SUPPLEMENTAL BID BULLETIN No. 012-2022

SUBJECT : Revisions in the Bidding Document

PROJECT/S : 1 Lot Supply and Materials for the Replacement of Existing Steel Framed Glass Window to Aluminum/PVC Framed Glass Windows Along the 2nd Floor Peripheral Corridor of the Hospital Building - ITB No. 003.22

DETAIL SECTION

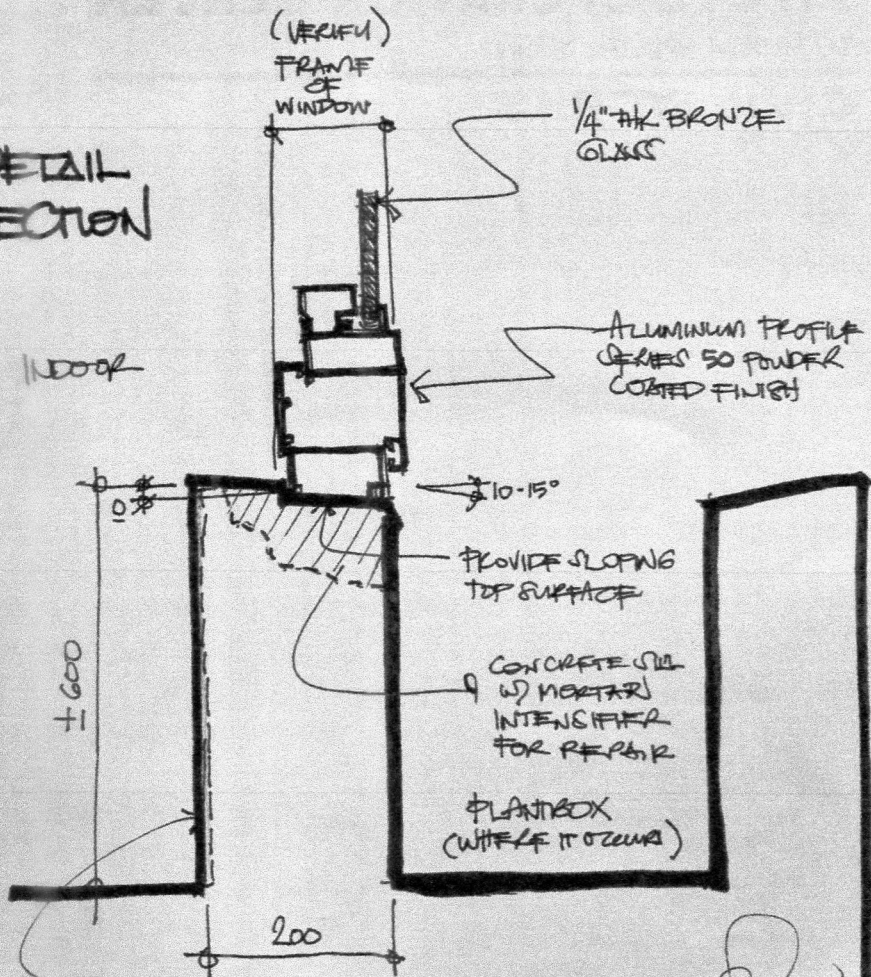
Item No./ Page No.	PHC – Technical Specifications FROM	Clarifications/Modifications (Should be read as) TO
1.2 Page 1	Temporary Facilities	Temporary Facilities This includes board-ups to separate working area from hospital premises, safety covers to protect people below, scaffolding and temporary covers on window openings for protection from rain. This also includes temporary storage of window material.
Page 2	Concrete Window Sill Detail	- see attached drawing/layout for reference
Page 3	For Waterproofing	Elastomeric type is added to waterproofing list (cementitious, membrane, hot applied). THAT IS NOT ACCEPTED as these has failed based on previous experience.

INTERIOR WALL TOP FRANK &
WATERPROOFING.
